VEC spec for 50GAUI-1 C2M and 100GAUI-2 C2M

P802.3cd Draft 2.2 comment 30

P802.3cd Draft 3.0 comment 114

What the spec allows

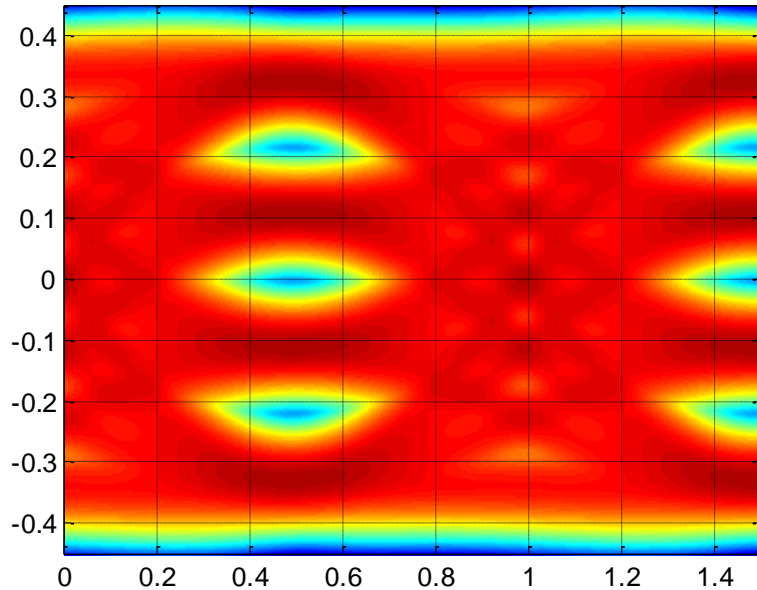
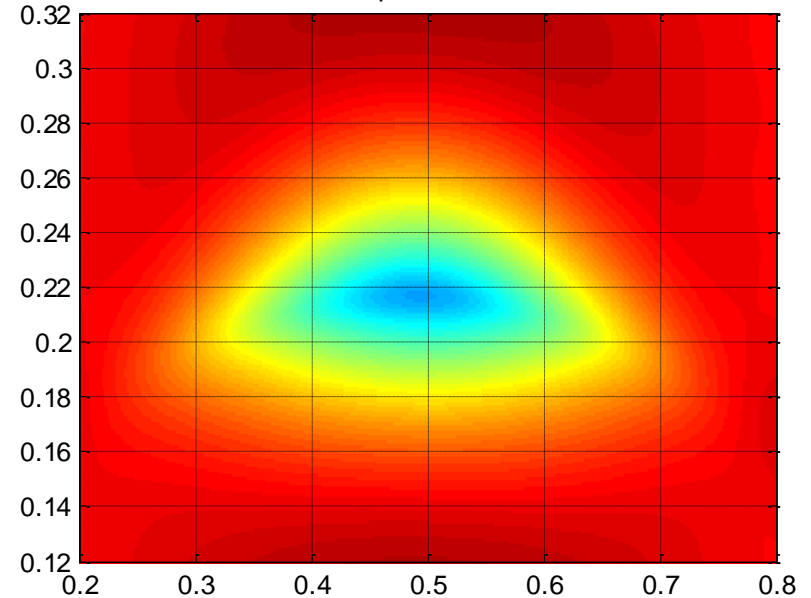
- This output from a low loss host is allowed by the spec. The signal is more than 2.5x bigger (0.83 V pk-pk vs. 0.31 V after CTLE) but the eye height (usable opening) is still only 35 mV for eye width at minimum. This signal's **VEC is 15.8 dB**.
 - It was hoped that the eye width spec (0.22 UI) would enforce a better eye height. But it doesn't do so significantly – a host could have less UBJ and more noise than this one, taking the eye height closer to the minimum 32 mV

- The module stressed input signals (slides 4, 7) have VEC around **8 dB**
- The bigger, blurry, but still near minimum height, eye (slide 5) has a VEC about **16 dB**
- A low loss host might have a worse VEC than a high loss host, but not 8 dB worse
- **Limit the host output VEC to 12 dB**
 - There is no need to do the same for the module output because the signal swing is limited before the host loss and the minimum eye height is enforced both before and after it
 - Use VEC rather than V_{pkpk} / eye height because we know how to specify and measure it
 - See P802.3bs D2.0 120E.4.2.1 Vertical eye closure
 - This was removed for D2.1 because it was not needed for the module output as well as the far end eye spec (D2.0 comment 173)
- **This change should be made in sponsor ballot (now)**

Module stressed input signal, low loss

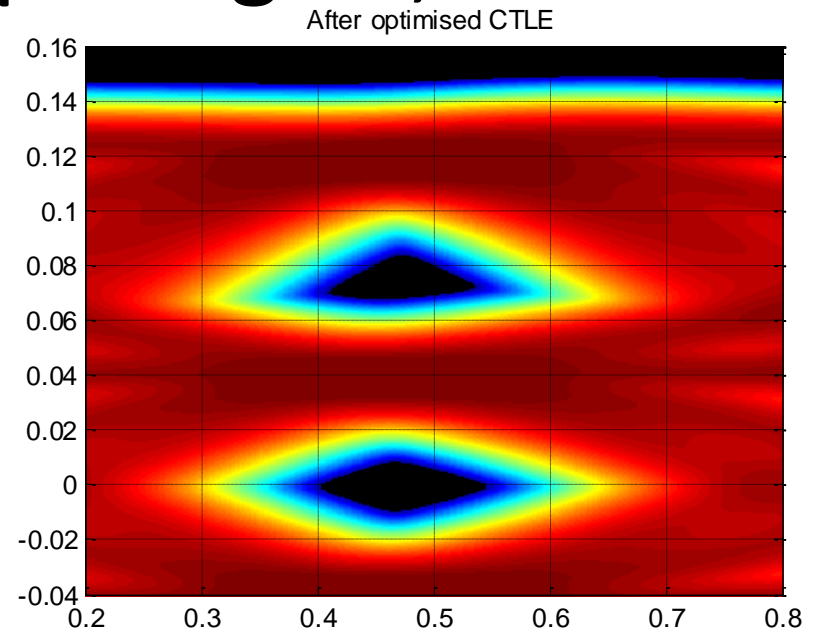
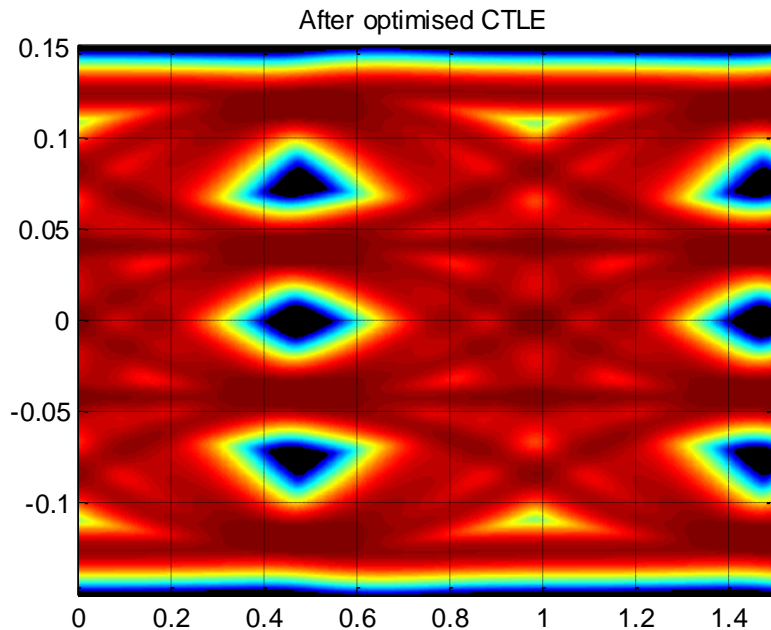
- Eye height 31.7 mV, width 0.219 UI (target is 32, 0.22)
- **VEC is 7.9 dB** CTLE is at 2.5 dB ~0.28 V pk-pk after CTLE
- Nominally 342 mV at driver, no emphasis. Much cleaner and less pk-pk swing than host is allowed
 - (as expected / intended)
- In this case, the 1e-5 contour is in the green region. Because this is a pdf not a cdf, it won't be quite the same in other cases

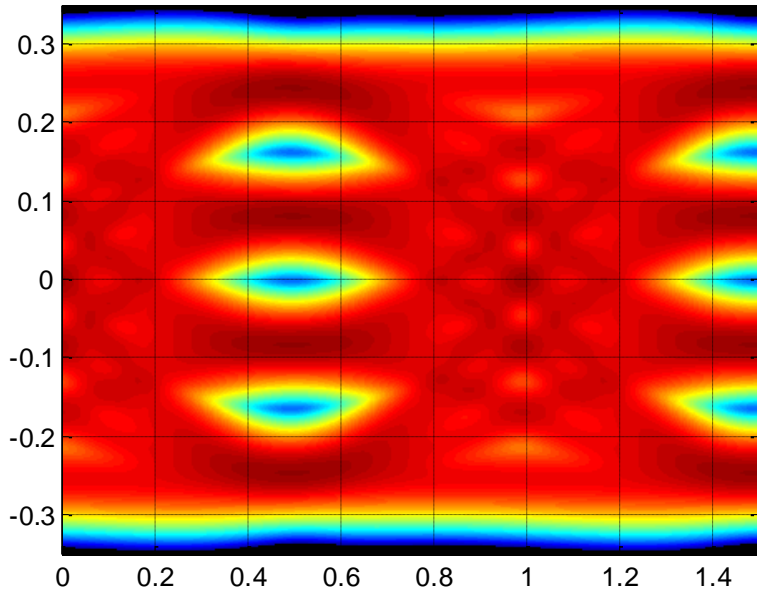
- *Cl 135G SC 135G.3.1 P 375 L 22 # 30* *Type TR*
- As shown in http://ieee802.org/3/bs/public/adhoc/elect/05Oct_17/dawe_01b_100517_elect.pdf there is a need for an additional spec to protect the module from e.g. very noisy hosts, and a max VEC spec provides worthwhile protection.

- *SuggestedRemedy*
- Here, add a requirement for VEC, max 12 dB. In 135G.4, add definition of VEC, which was in P802.3bs D2.0 120E.4.2.1 (the AVs were illustrated in Figure 120E-13, although they could be on Fig 120E-14 and the text under what was equation 120E-3 is clear enough so we don't have to add them to the figure).

- Add PICS to 135G.5.4.1.
- REJECT.
- This comment does not apply to the substantive changes between IEEE P802.3cd D2.1 and D2.2 or the unsatisfied negative comments from the initial ballot. Hence it is not within the scope of the recirculation ballot.

- Viewed [dawe_3cd_01_1117](#). There was general agreement with the proposal.
- A presentation providing detailed implementation is encouraged.
- **The commenter is encouraged to resubmit this comment at Sponsor ballot.**

What a 14 dB spec would allow

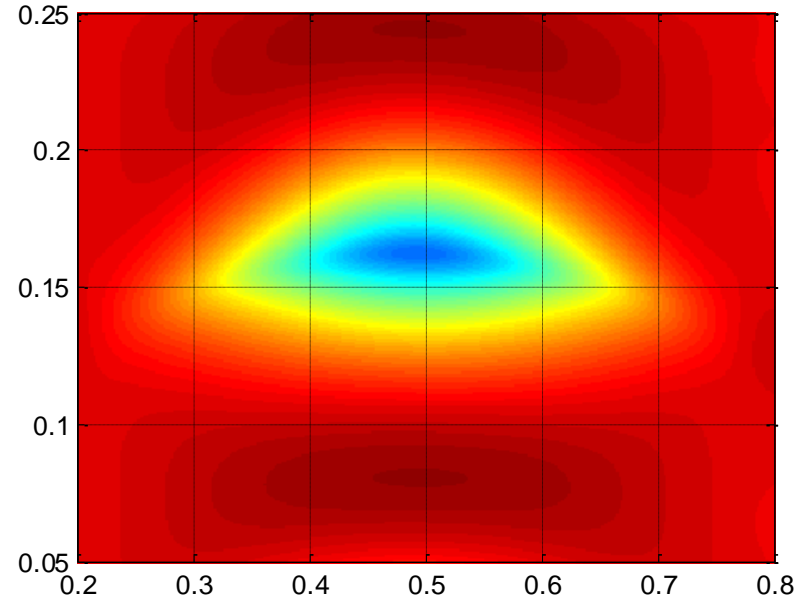
- This signal 0.67 V pk-pk after CTLE
- **VEC is 13.8 dB**
- Eye height is 33 mV

What a 12 dB spec would allow

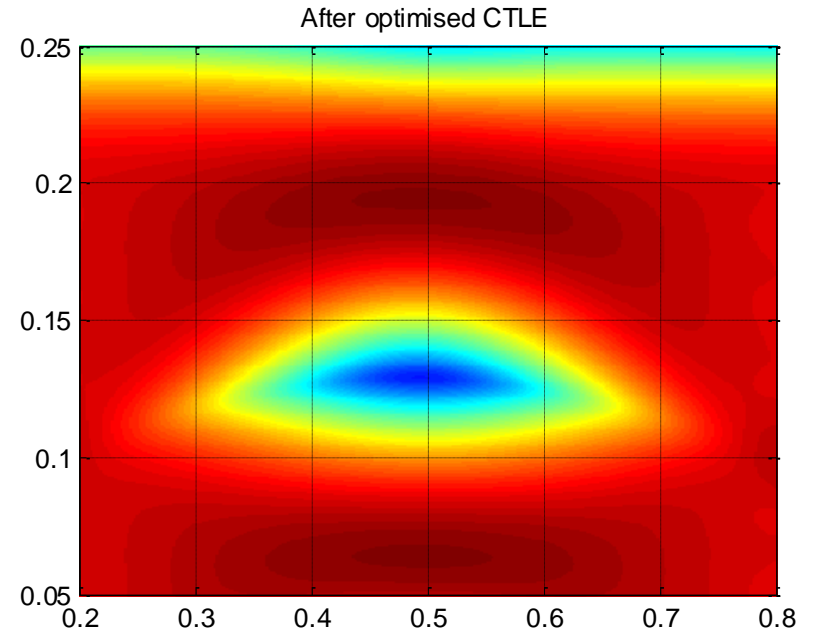
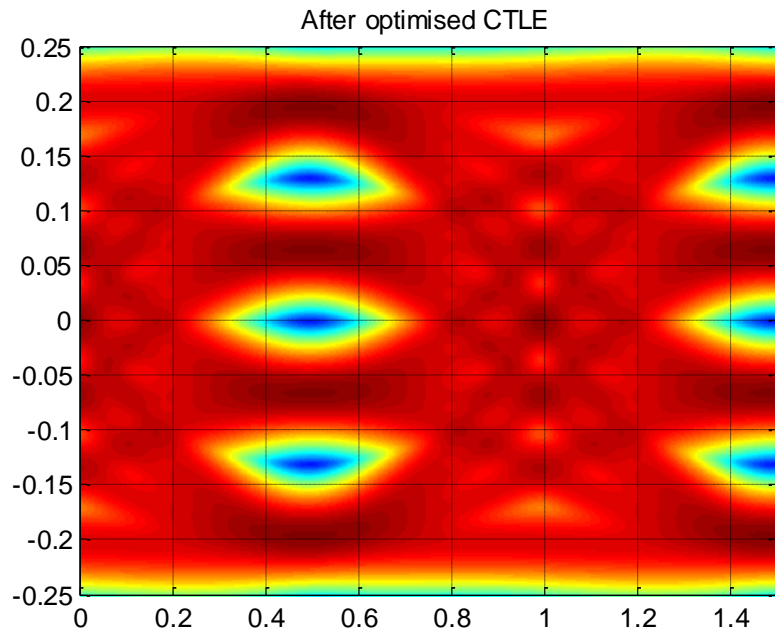
- This signal 0.49 V pk-pk after CTLE
- **VEC is 12.0 dB**
- Eye height is 32.6 mV
